CLUTCH CONTROL HAND LEVER — ELECTRA GLIDE

HARLEY-DAVIDSON MOTOR CO.

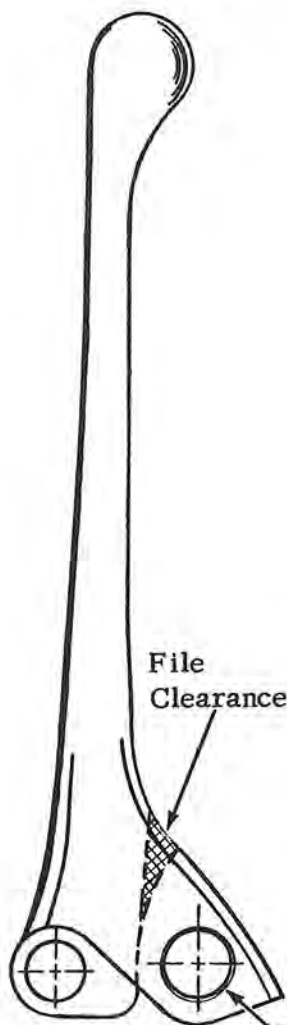
The Electra Glide clutch control hand lever has been changed during the 1968 season to incorporate nylon bushings for the cable anchor pin. To accommodate the bushings, the diameter of the pin was reduced and the hole size increased. Also the slot width in the lever end was increased and more clearance provided in the bottom of the slot.

The present early 1968 hand lever can be reworked to accept the new nylon bushings and pin by drilling out the hole and filing out the slot as shown in the illustration. In this case order 2 new bushings, part No. 45039-68 and one pin 45036-68 for each repair.

Drill out to 1/2 inch diameter.
(Important) This must be done carefully in a drill press with a drill vise to hold lever in perfect alignment.

File both inside surfaces of slots an equal amount so that bushings can be inserted as shown.
